SUBJECT: ADDENDUM # 3

PROJECT TITLE: West Campus Development – Phase 2
Norwalk Community College
Norwalk, Connecticut

PROJECT NO.: BI-CTC-406

BID OPENING	1:00 P.M.	August 12, 2009
ADDENDUM NUMBER THREE	DATE OF ADDENDUM	August 3, 2009

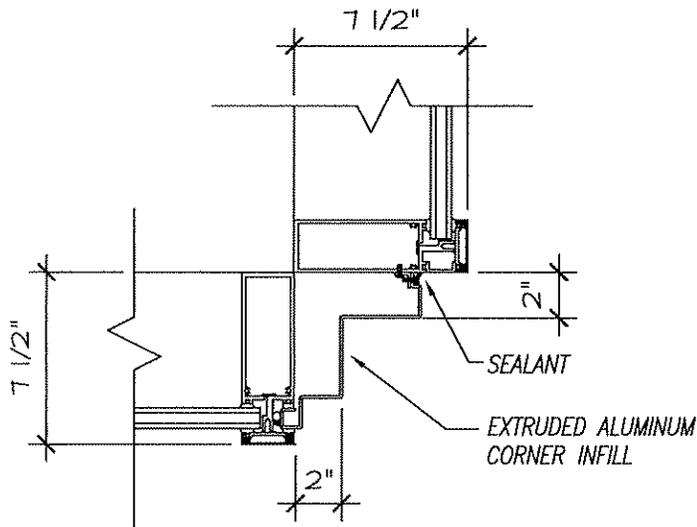
On Drawing A2.00, on Ground Floor Plan: New Building, in Lobby/H013, change wall finish to "W2" as indicated on attached Sketch SK-A2.00-B dated 30 July 2009.

06-A DETAIL © EXTRUDED ALUM. FILLER
 1 1/2" = 1'-0"

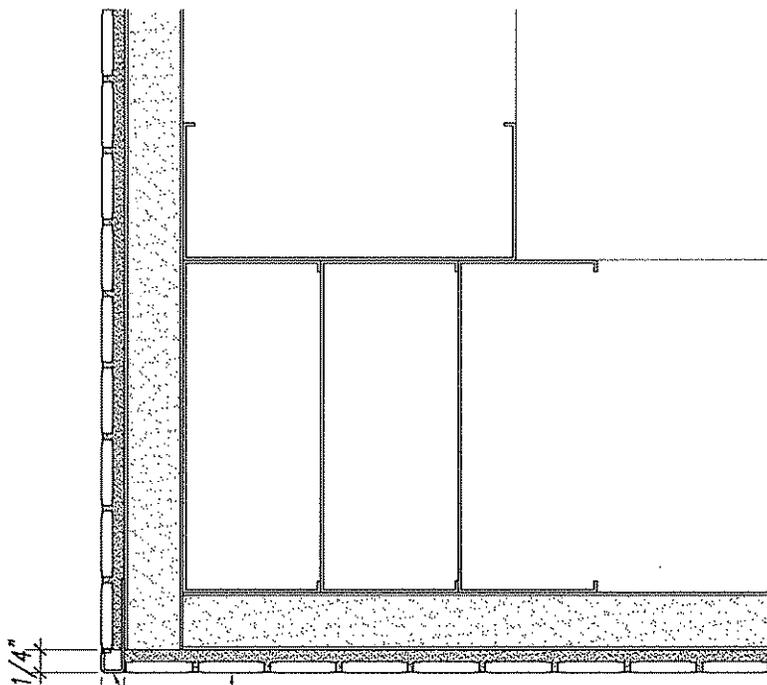
On Drawing A6.00, on Plan Details/Exterior Details, add new Detail 06-A as indicated on attached Sketch SK-A6.00-A dated 30 July 2009.

DETAIL PLAN SECTION: TYP TILE OUTSIDE CORNERS
6" = 1'-0"

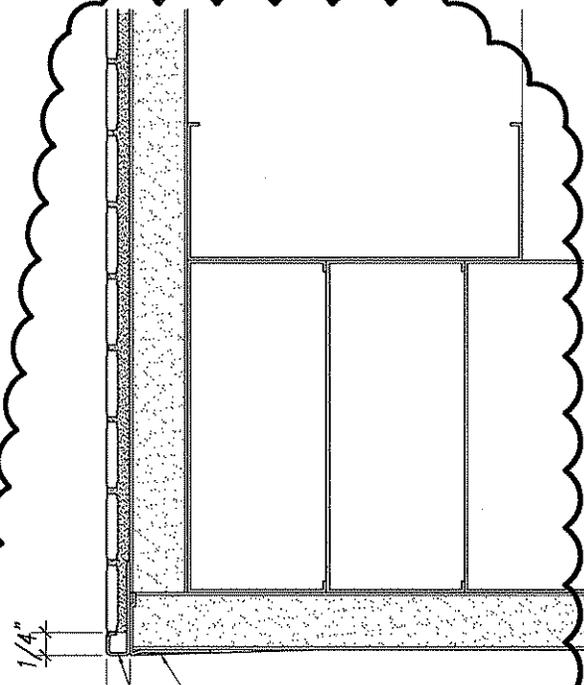
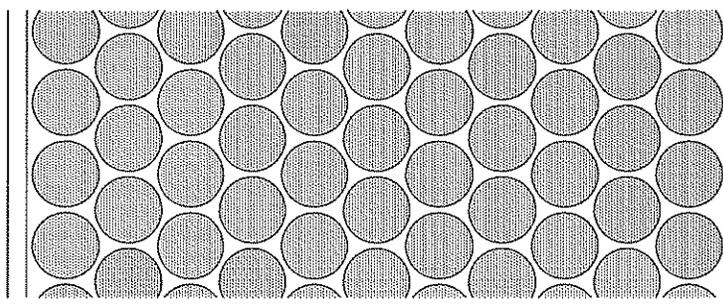
On Drawing A7.05, on Interior Details, revise Detail 08 as indicated on attached Sketch SK-A7.05-A dated 30 July 2009.

ARTWORK FOUNDATION

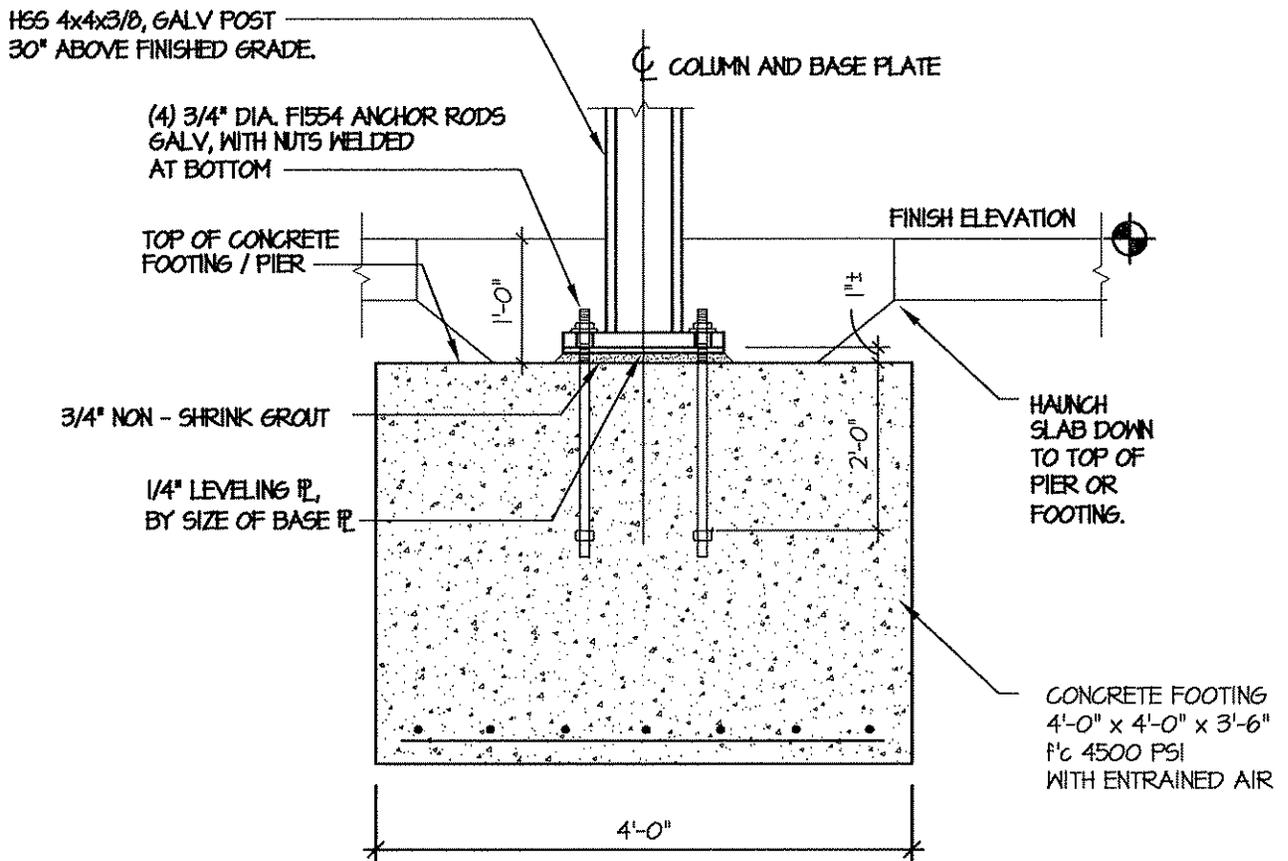
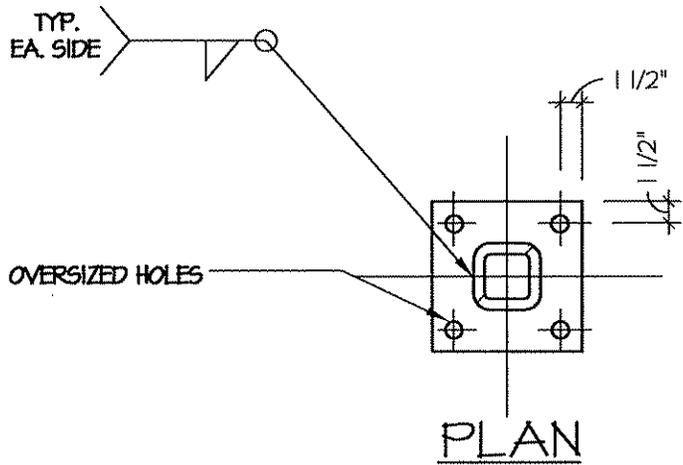
On Drawing S3.01, on Structural Foundation Details, add new Details of Artwork Foundation as indicated on attached Sketch SK-S301-A dated 30 July 2009.

1 ART PIECE LAYOUT

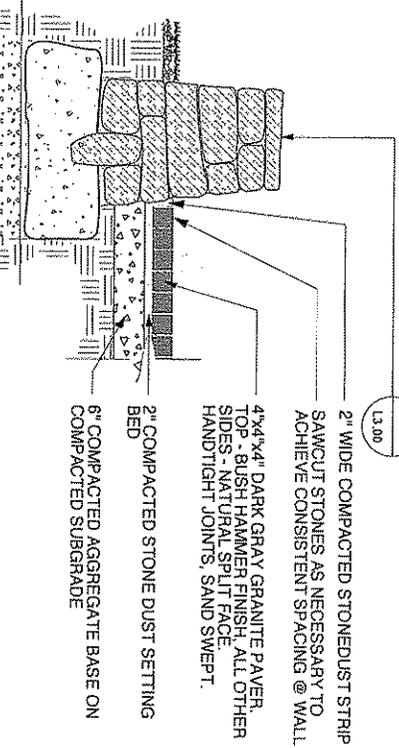
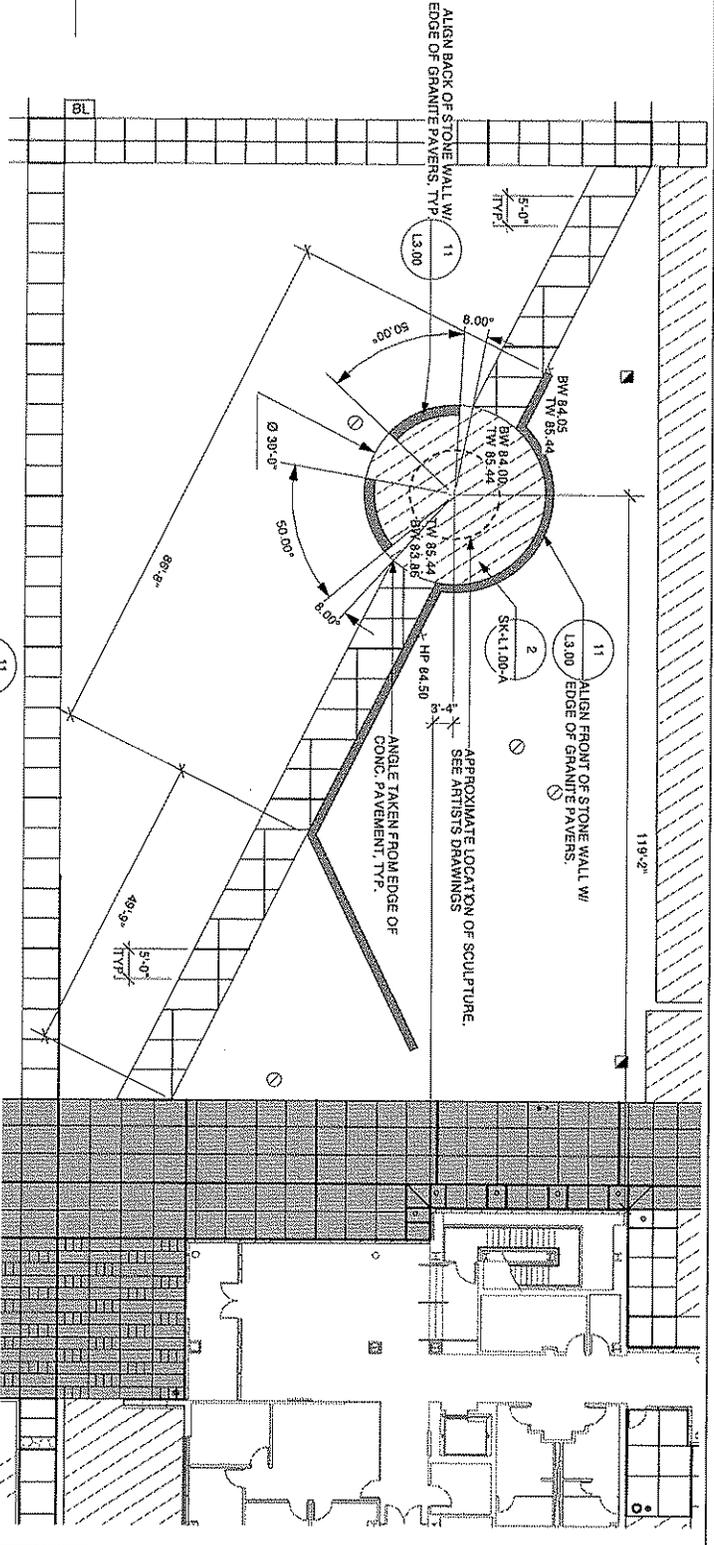
On Drawing L1.00, add Art Piece Layout and Granite Cobble Paving Detail as indicated on attached Sketch SK-L1.00-A dated 30 July 2009.

GAS TRAIN PIPING DIAGRAM
 TYPICAL FOR FOUR BOILERS

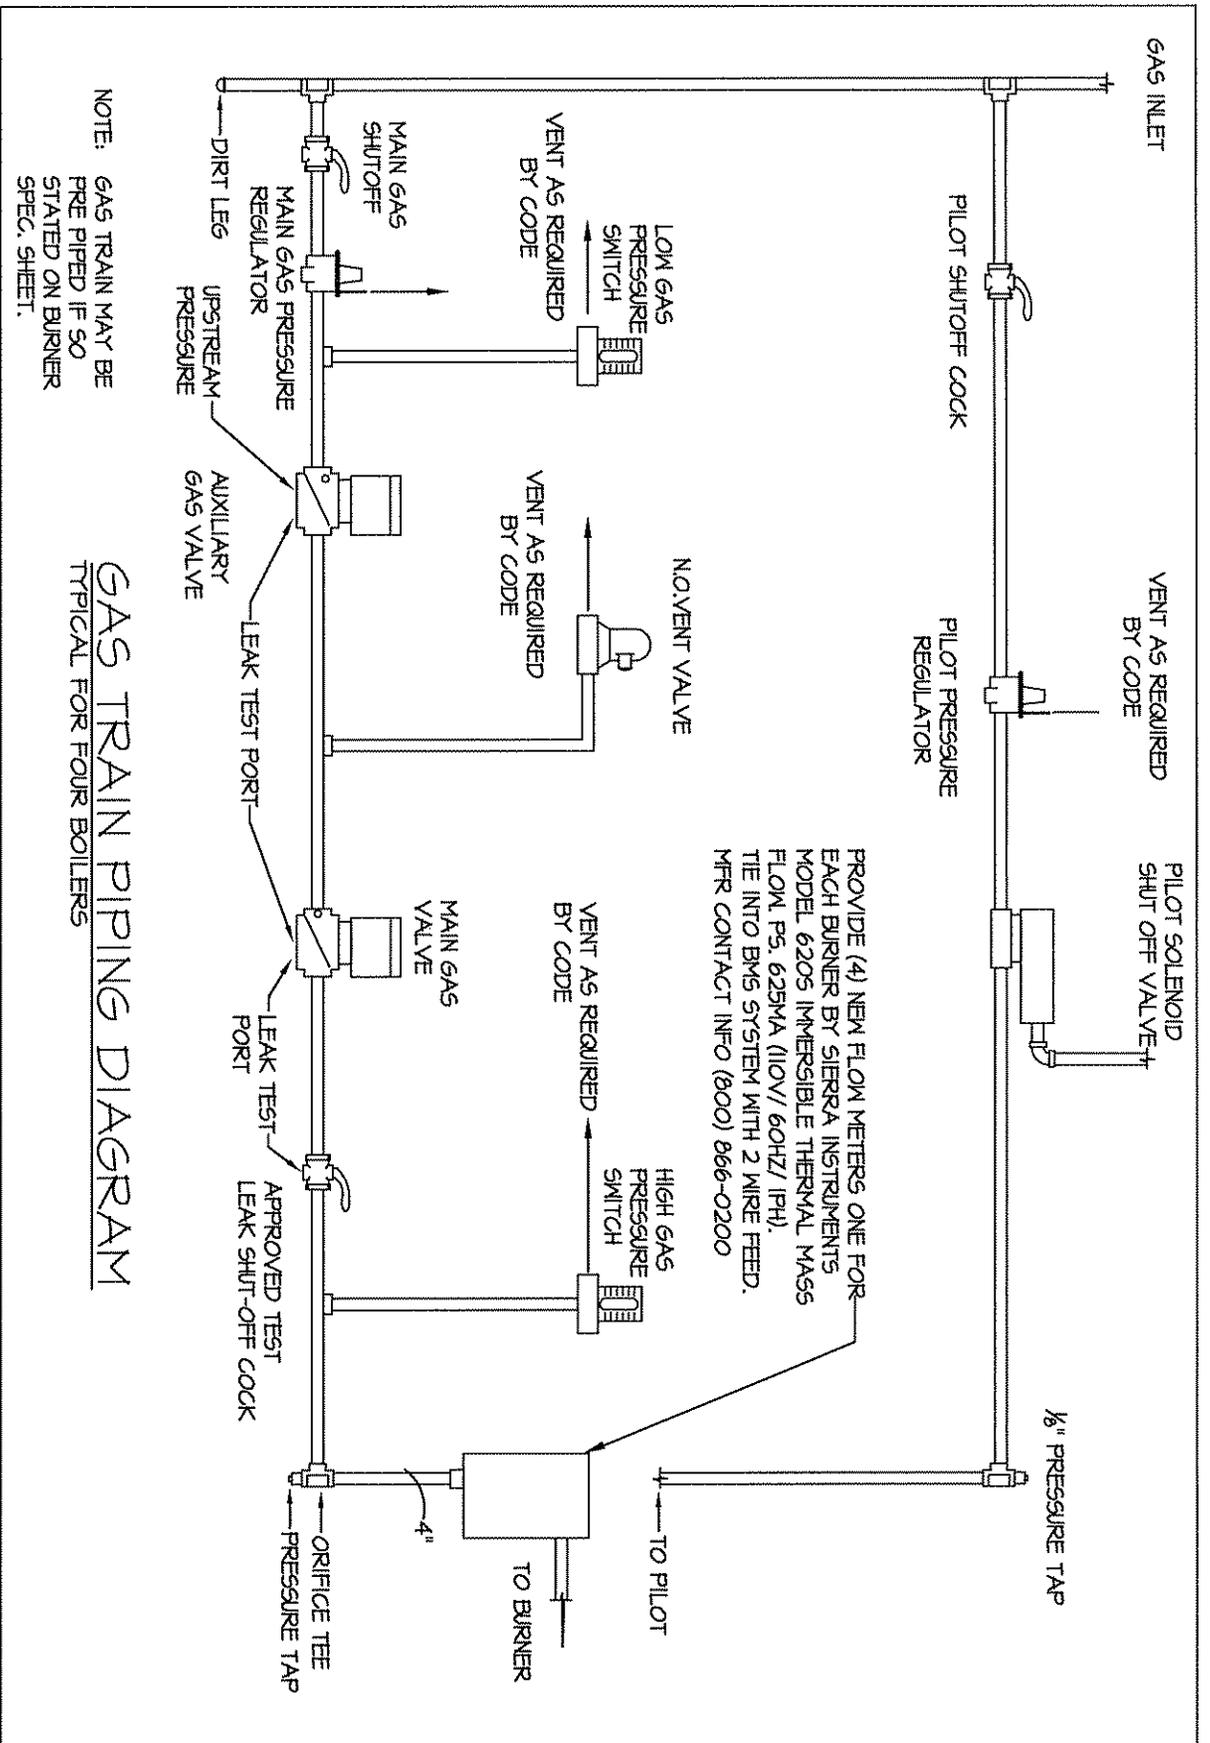
- k. Addenda number 1, on drawing number SK-M-3.06 A & B state provide (4) New oil flow meters and (4) New Flow meters to connect to BMS system. Who will be installing, wiring and purchasing these (8) eight flow meters?

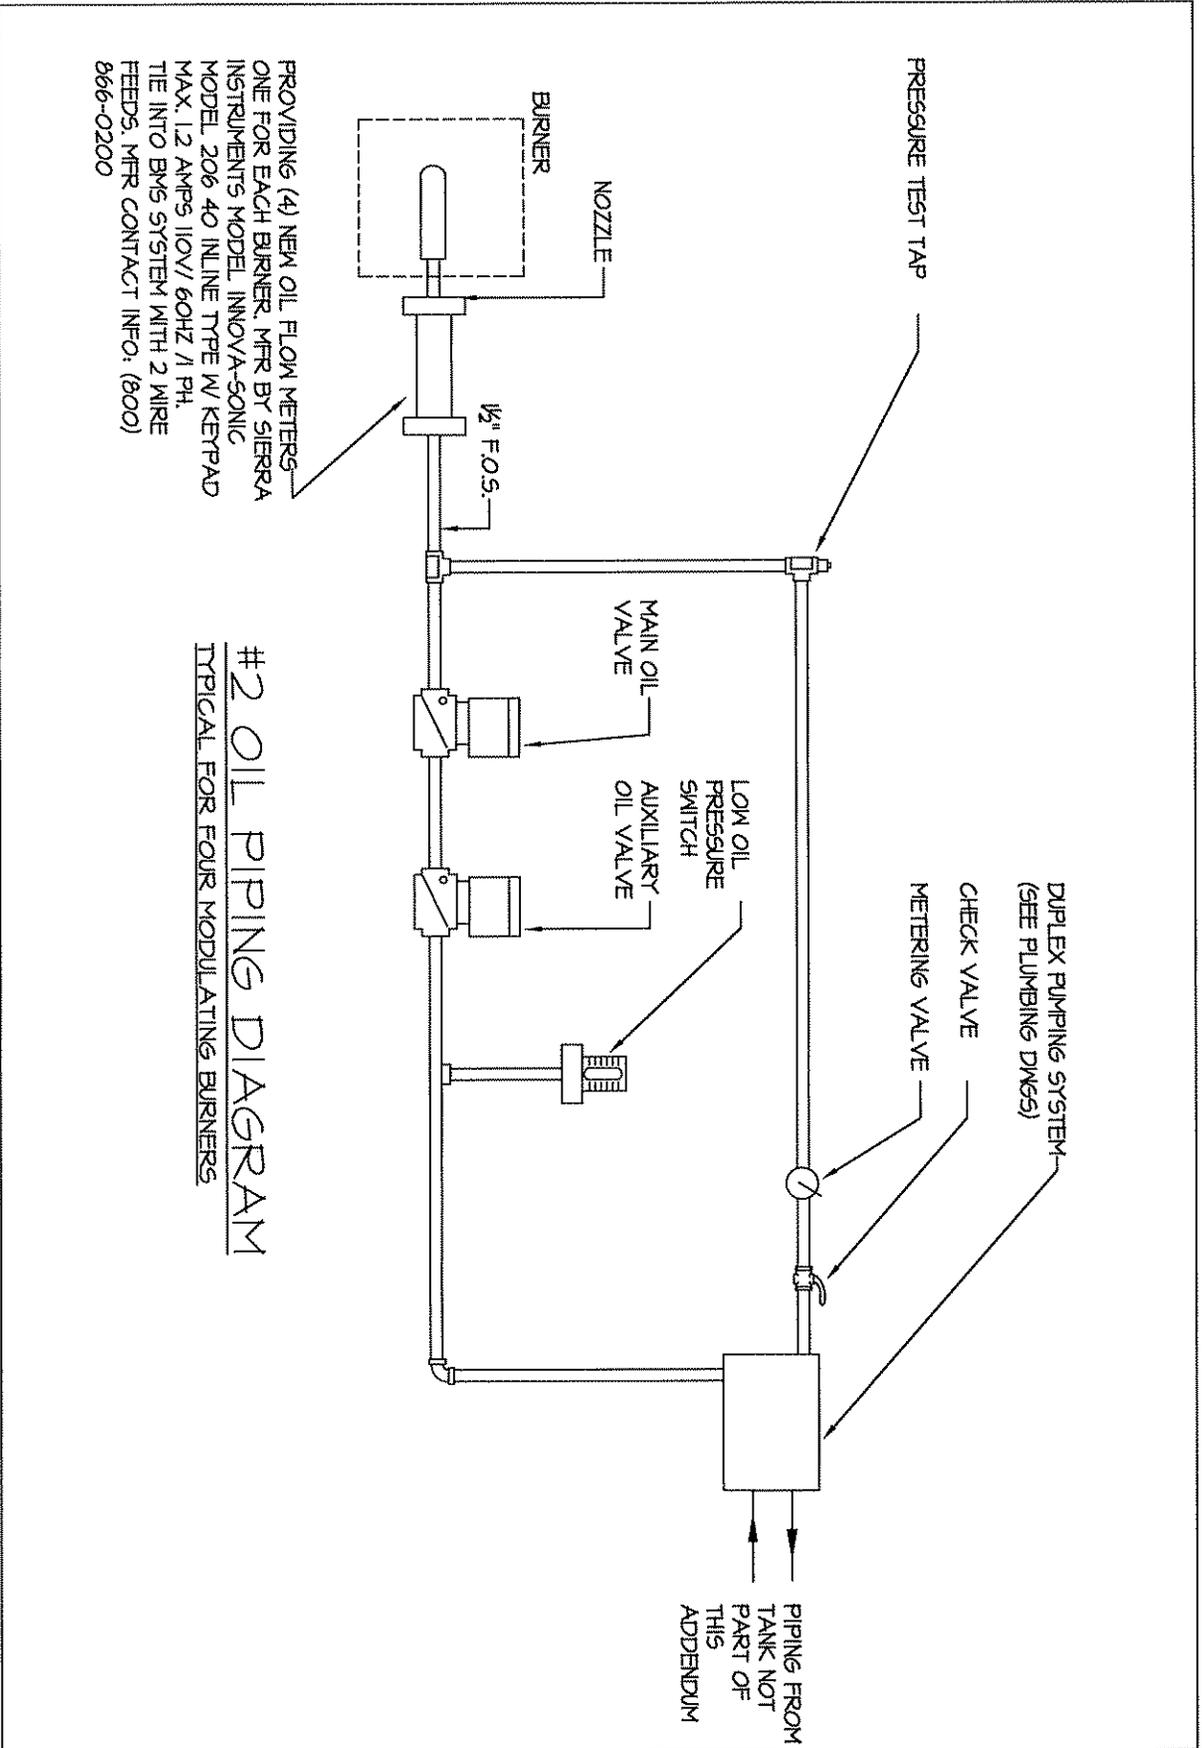
PROVIDING (4) NEW OIL FLOW METERS
 ONE FOR EACH BURNER. MFR BY SIERRA
 INSTRUMENTS MODEL INNOVA-50NIC
 MODEL 206 40 INLINE TYPE W/ KEYPAD
 MAX. 1.2 AMPS 110V/ 60HZ /1 PH.
 TIE INTO BMS SYSTEM WITH 2 WIRE
 FEEDS. MFR CONTACT INFO: (800)
 866-0200
